Nightmute Airport Improvements
Project 51809
Environmental Re-Scoping

Nightmute Airport Improvements
51809

Re: Nightmute Airport Improvements
Re-Scoping Comments

| STATE OF ALASKA DEPARTMENT OF TRANSPORTATION AND PUBLIC FACILITIES CENTRAL REGION-DESIGN AND CONSTRUCTION-AVIATION | Nightmute Airport Improvements 51809 Project Scope Figure 2a |

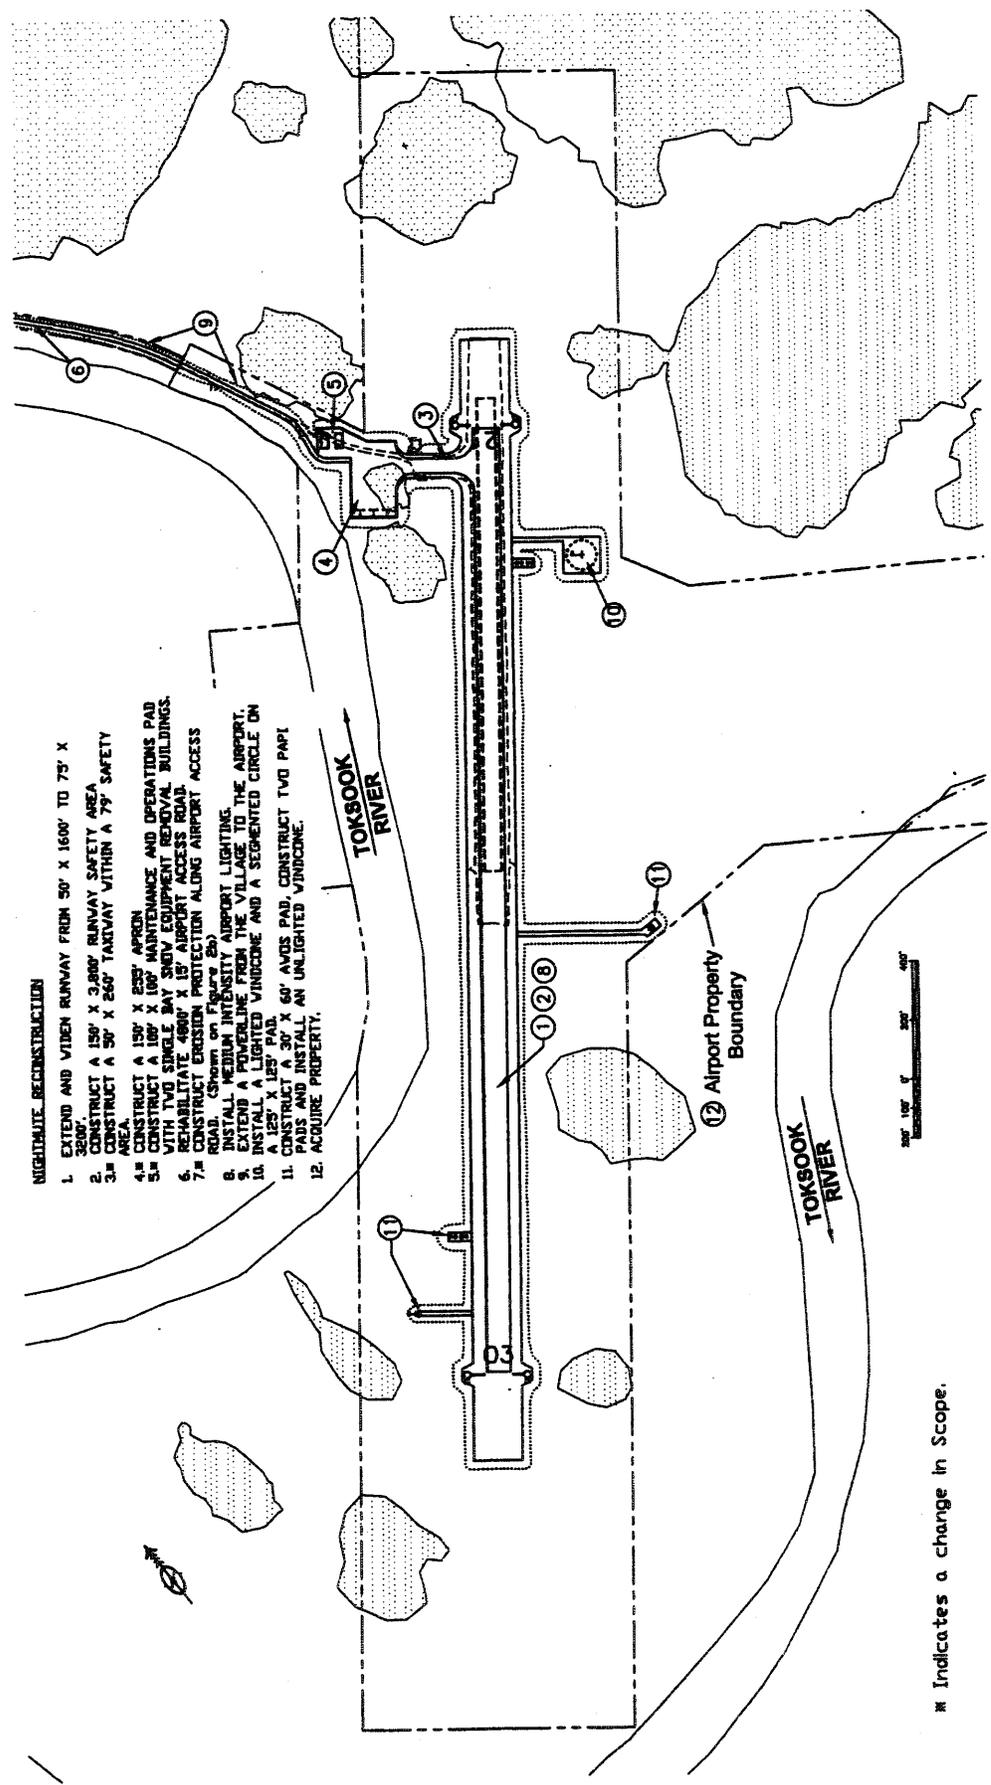
Appendix I of the Airport MOU provides guidance on Avoidance and Minimization Procedures (AMPs). We believe design aspects of several project components need to be re-evaluated in light of paragraphs 2), 3), and 4) of the AMPs. Specifically, we call attention to the positioning of the 100-ft by 100-ft maintenance and operations pad and the new 150-ft by 255-ft parking apron. Both of these components are proposed to be placed on filled higher value wetlands (e.g., open water, emergent). Under the terms of paragraph 4), measures to minimize such loss are to be taken, including locating the improvements outside of such high value habitat. We recommend these improvements be repositioned on higher, drier ground either adjacent to the northeastern terminus of the runway or that they be moved to the south side of the runway adjacent to the area proposed as the site for the new lighted wind cone.
